INDESIT company

Model type:
IDV75EX60HZ

Commercial code:
F062985

07430-21 Exploded views

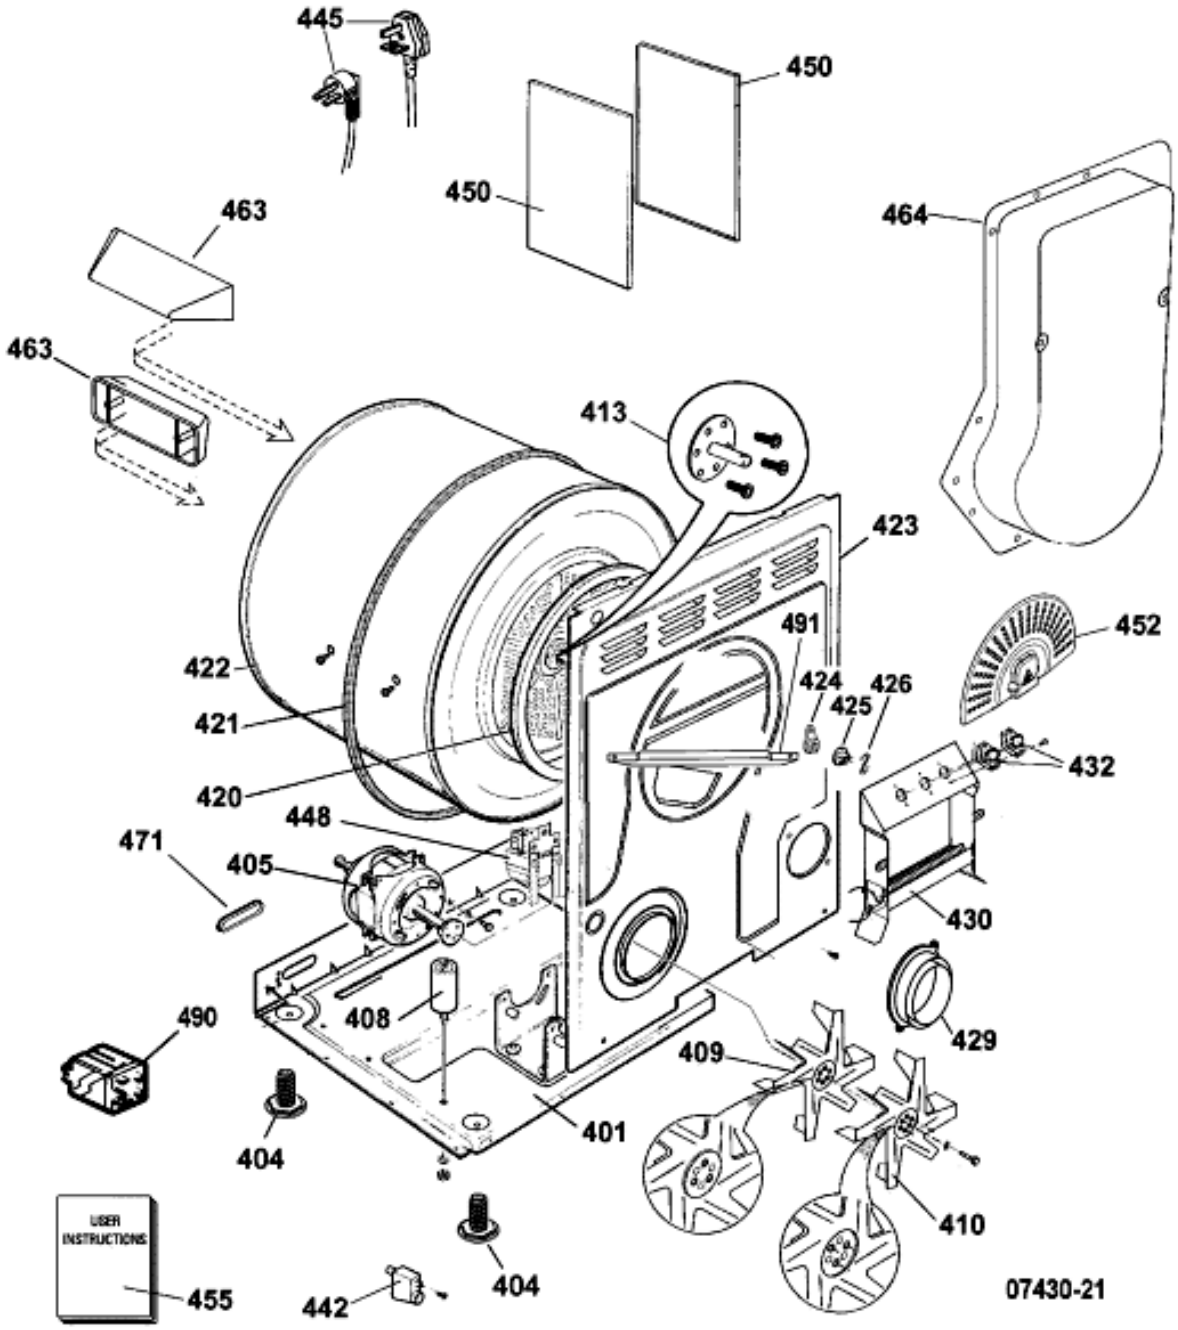
n4408a01: VENTED TUMBLE DRYER HEATERS

From Serial Number 70802.0001, Two different Heater manufacturers were used in production. These DBK and Blaissi Heaters are totally interchangeable if replaced as an assembly.

But the thermostat kits for these Heaters are not interchangeable.

From Serial number 70802.0001, before a Stat. Kit is replaced the heater fitted to the machine must be identified first.
The cover of the Blaissi heater has 2 raised dome shaped pips, there is also a Blaissi Label inside the heater attached to the inside of the heater cover
The Cover of the DBK Heater has 4 raised dome shaped pips.

n4410l01: NEW VENTED MECHANICAL HEATER

FROM SERIAL NUMBER 01207.0000 A NEW HEATER WITH A COLOMBO CONNECTOR HAS BEEN USED IN PRODUCTION.
THIS NEW HEATER IS NOT INTERCHANGEABLE WITH THE PREVIOUS ONE.

n4412c01: VENTED TUMBLE DRYER DRUM LIFTER

From Sept 2011, a curved drum lifter, has been used in production, the new lifter is fully interchangeable with the original straight drum lifter, once stock of the straight drum lifter is exhausted, the curved drum lifter will become the Service Spare, for all production dates".

07475-15 Exploded views

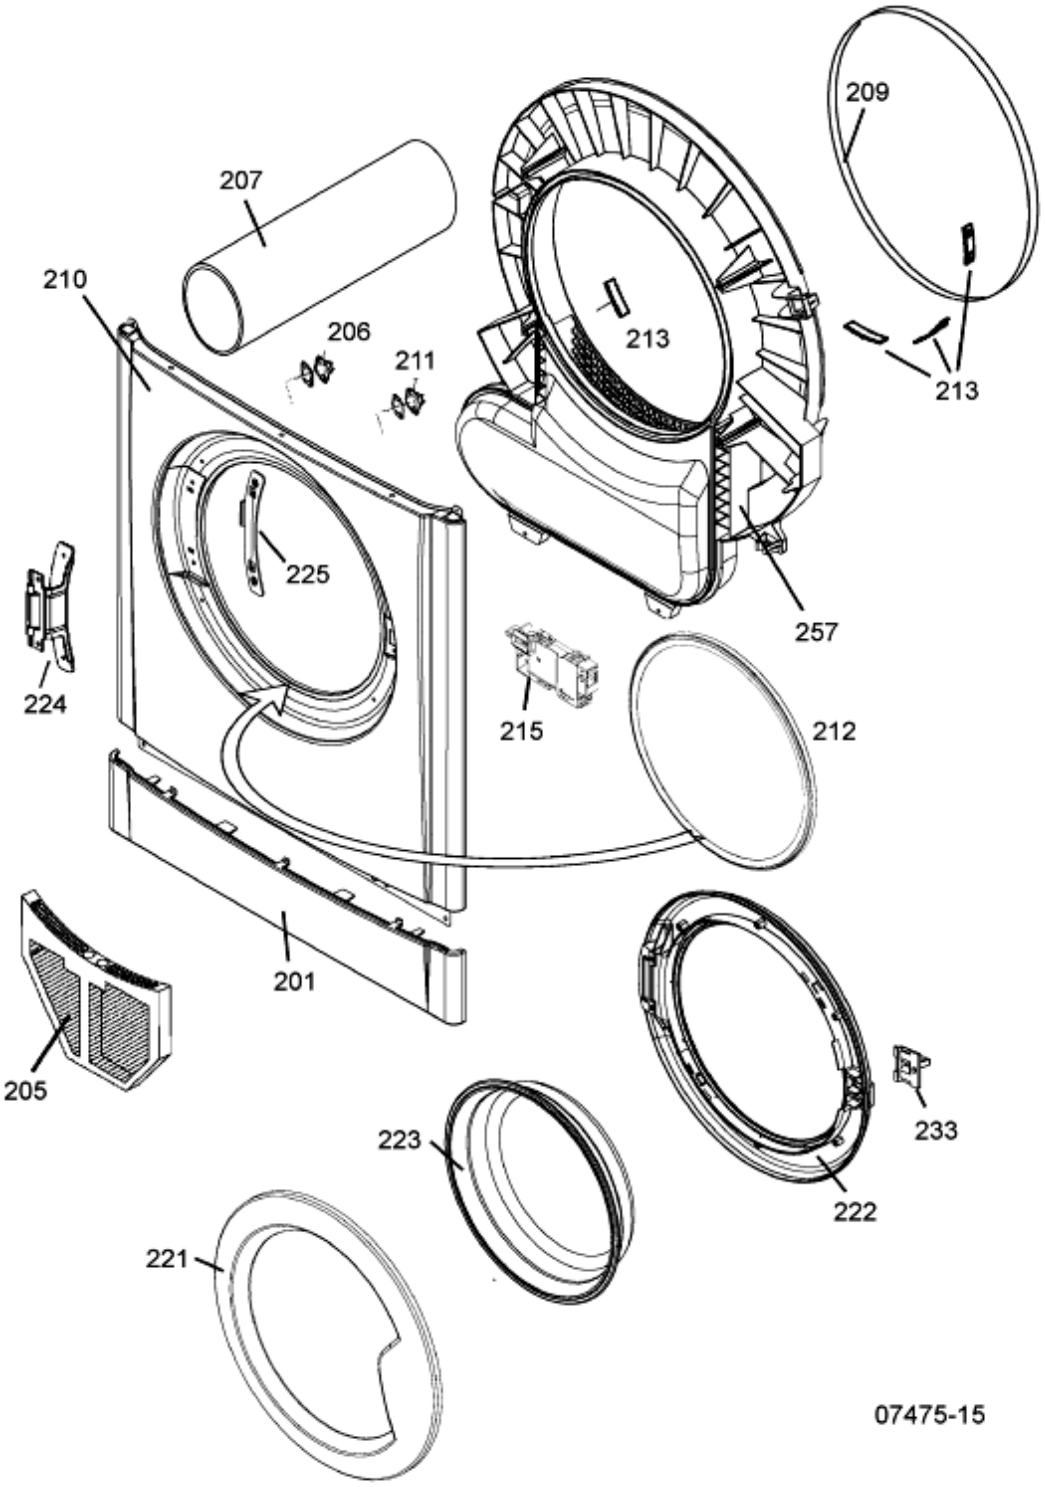
n4409k00: FRONT AIR DUCT & AIR DUCT SEAL

FRONT AIR DUCT SEAL
Both 14mm and 16mm Air Duct Seals have been used in production.
14 mm - used Before Serial No. 50501.0000 (May 2005)and After 00115.0001 (Jan 2010)
16 mm - used Between Serial No.s 50501.0001 (May 2005) and 00115.0000 (Jan 2010) - See note below
If replacing only the Seal - select the CORRECT size from the parts list.
AIR DUCT
White Air Ducts were used in production from 10601.0000 (June 2011), the only difference to the Grey Ducts is the colour change.
WHITE AIR DUCTS ONLY will become the only Service Air Duct Once Stock of the Grey Air Ducts is exhausted

If the original air duct is grey, the air duct kit is required which includes a white filter.
NOTE: ALL SERIAL NUMBERS:
If the AIR DUCT is being replaced you will require a 14mm Seal because the service replacement AIR DUCT is 14mm. See parts List

n4411g04: COLOUR CHANGE TO THE FILTER> VENTED DRYERS

FROM JUNE 2011 THE FLUFF FILTER FITTED TO VENTED TUMBLE DRYERS CHANGED IN PRODUCTION FROM GREY TO WHITE.
SELECTED THE CORRECT PART BY DESCRIPTION IN THE PARTS LIST

n4411g06: COLOUR CHANGE TO WHITE FRONT AIR DUCT

FROM JUNE 2011 THE FRONT AIR DUCT FITTED TO VENTED TUMBLE DRYERS CHANGED IN PRODUCTION FROM GREY TO WHITE.
SELECTED THE CORRECT PART BY DESCRIPTION IN THE PARTS LIST

n4414h00: VENTED AIR DUCT-FILTER FRONT SEAL

FROM JUNE 2011 THE FRONT AIR DUCT FITTED TO VENTED TUMBLE DRYERS CHANGED IN PRODUCTION FROM GREY TO WHITE.
ONCE STOCK OF THE GREY AIR DUCT IS EXHAUSTED, ONLY THE WHITE WILL BE THE SERVICE SPARE.

FROM JUNE 2014 IN A PHASED INTRODUCTION A NEW VENTED AIR DUCT, FILTER AND DRUM FRONT SEAL HAVE BEEN USED IN PRODUCTION.
THESE NEW PARTS ARE NOT INTERCHANGEABLE. SEE PARTS LIST
